CITY COMMISSION STAFF REPORT

46 Marine Way

Meeting	File No.	Application Type
August 18 th , 2026	HP-544-2026	Certificate of Appropriateness, Demolition, Relocation, Variances, & Waivers

REQUEST

Proposed streetscape – FEMA elevated

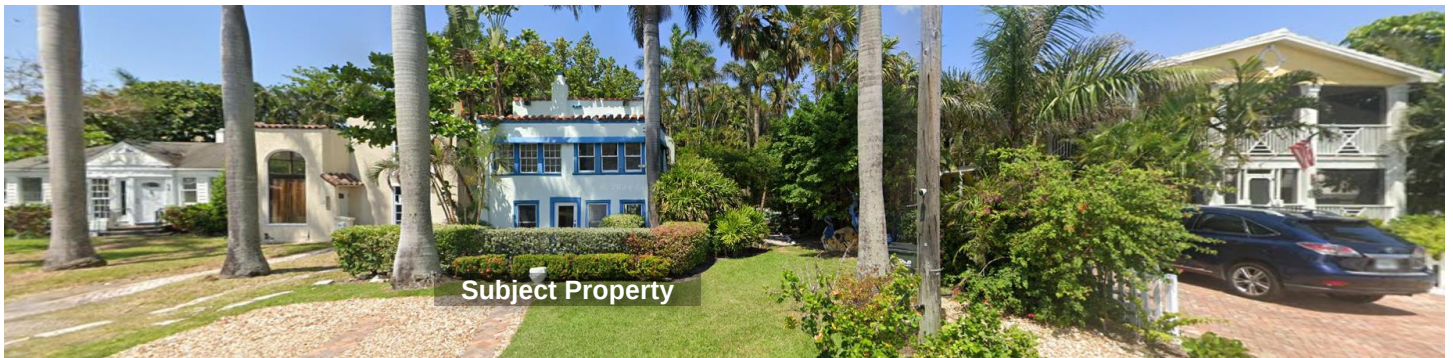
As mentioned previously, the structure is being raised to meet the current FEMA requirements, and as a result, preserving the existing principal structure for the future. The request incorporates architectural elements currently on the existing structure, while allowing the existing proportions to remain. Along the front (east), the introduction of the arched carport entryway, and single hung window help alleviate the appearance of what would otherwise be a solid wall foundation. The proposed new carport wall finish is to be coral rock, in a style different to the existing organic rock style coral that exists on the north side of the structure. Consideration could be given to the introduction of landscaping around the base to further reduce the impact of the new wall. Below is imagery of the existing and proposed streetscapes of the subject structure and surrounding properties, (some that are under development review) and the future FEMA raised streetscape along Marine Way. These images depict examples of how alteration of a site and structure can impact the historic streetscape (regarding massing and height), and the historic integrity of the existing structure(s).

Waiver Request 1:

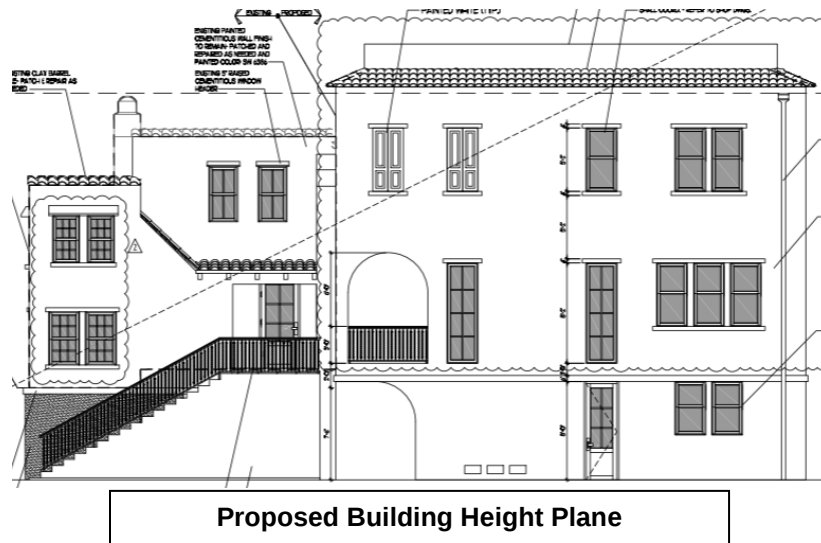
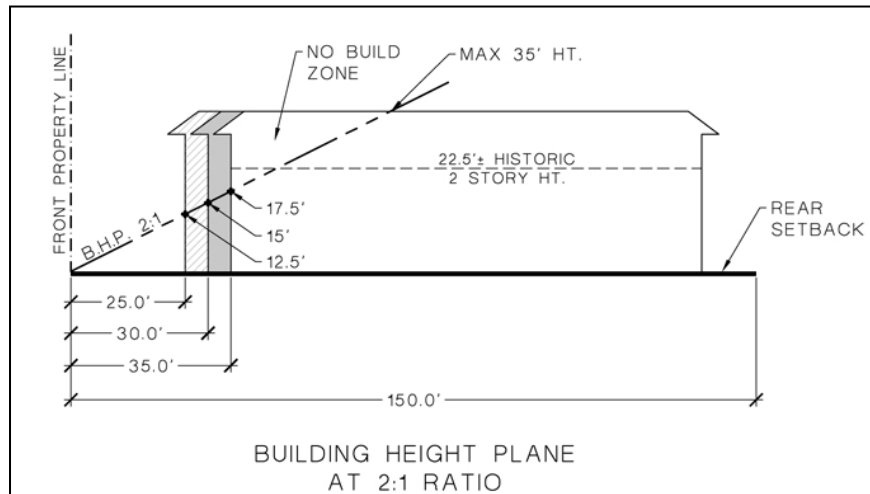
The Waiver request is to allow the existing vertically elevated structure and portions of the two-story addition to encroach within the required 2:1 Building Height Plane (BHP) ratio.

A large portion of the historic structure and portion of the new two-story addition fall within the "No Build Zone" of the BHP. It may not be possible to elevate the existing two-story structure to the minimum FEMA finished floor requirements without seeking a waiver to this visual compatibility standard, however the design of an addition could comply. Consideration could be given to keeping the structure at its lowest possible elevation per FEMA, to reduce the amount of the structure within the "No Build Zone". Should the proposal have planned for a one or shorter two-story addition it would reduce the impact upon the historic district and adjacent streetscape. The Commission will need to determine if the waiver results in a special privilege and if the same waiver would be granted under similar circumstances on other property.
